Assessment of Pacific Gas & Electric Company's Pipeline Safety Enhancement Plan

**Prepared For
Consumer Protection & Safety Division**

December 23, 2011

Figure 5 - PG&E Program Management Organization Structure

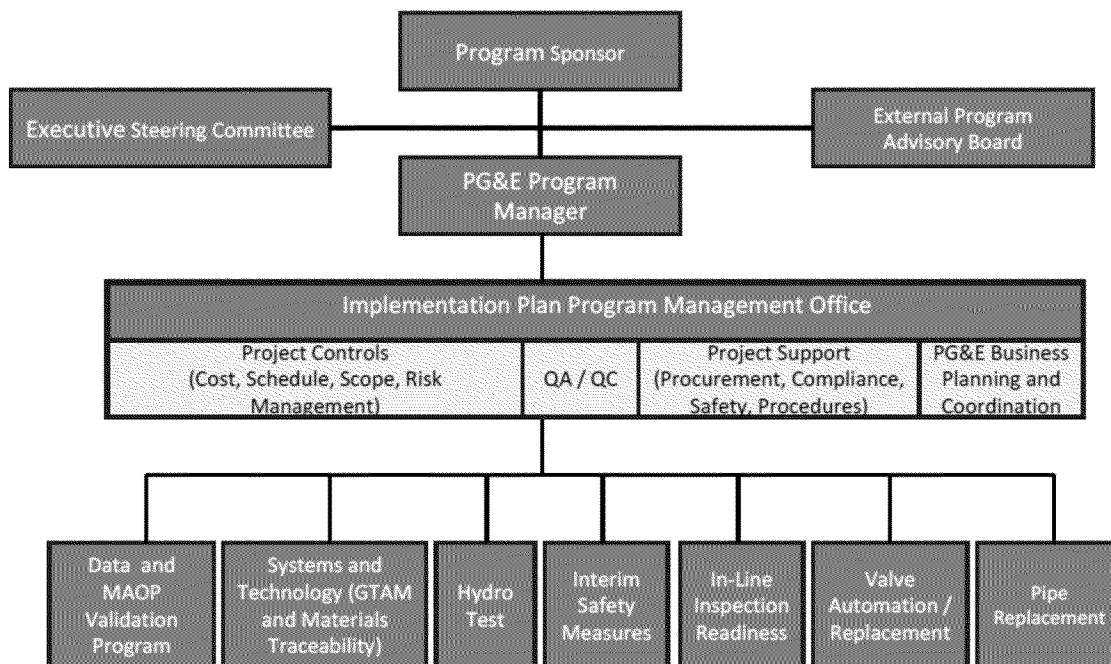
While the specific structure of a program management organization can somewhat vary based on a given program's size, complexity, and client needs, the PG&E program management organization structure, as shown in Figure 2, is consistent with industry practices, as are the roles and responsibilities of the major functions. The major functions of PG&E's programs management organization are:

- The Implementation Plan PMO organizational structure looks to provide a good framework. The organization and governance is based on current industry practices.

- 8.4.1 PG&E should be required to provide a copy of its PMO project execution/management plan for the PSEP in a format specified by the CPUC.
- 8.4.2 PG&E should report to the CPUC monthly the forecast and actual contingency draw down in a format specified by the CPUC.
